UNITED STATES PATENT AND TRADEMARK OFFICE

APPLICATION NO.	FILING DATE	FIRST NAMED INVENTOR	ATTORNEY DOCKET NO.	CONFIRMATION NO.
10/581,794	05/15/2007	Konrad Eipper	095309.57762US	8655

Office Action Summary	Application No. 10/581,794	Applicant(s) EIPPER, KONRAD	
	Examiner ERNESTO GARCIA	Art Unit 3679

DETAILED ACTION

Fig-2

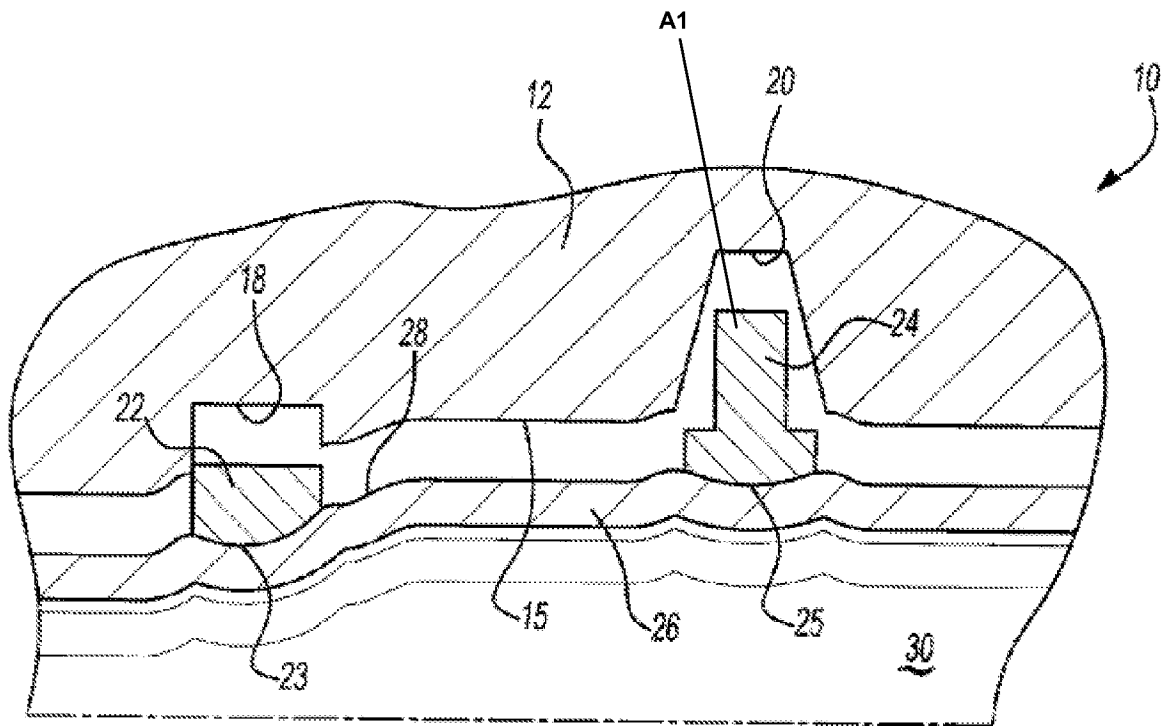
Regarding claim 13, Varela discloses, in Figure 2, a hollow profile joint comprising a hollow profile **28**, a joint part **24**, and an adhesive [016]. The hollow profile **28** is located in a through-opening of the joint part **24** at a joint point. The hollow profile **28** is expanded at least at the joint point and adjacent to the joint part such that an annular bead-shaped step, formed on the hollow profile **28**, bears against the joint part and the adhesive is located between an inner side of the joint part **24** and an outer side of the hollow profile **28** at the joint point.

Regarding claim 14, a fastening section **A1** (see marked-up attachment) is arranged on the joint part **24**. Note that the fastening section **A1** can permit fastening of the joint part and the hollow profile to another component.
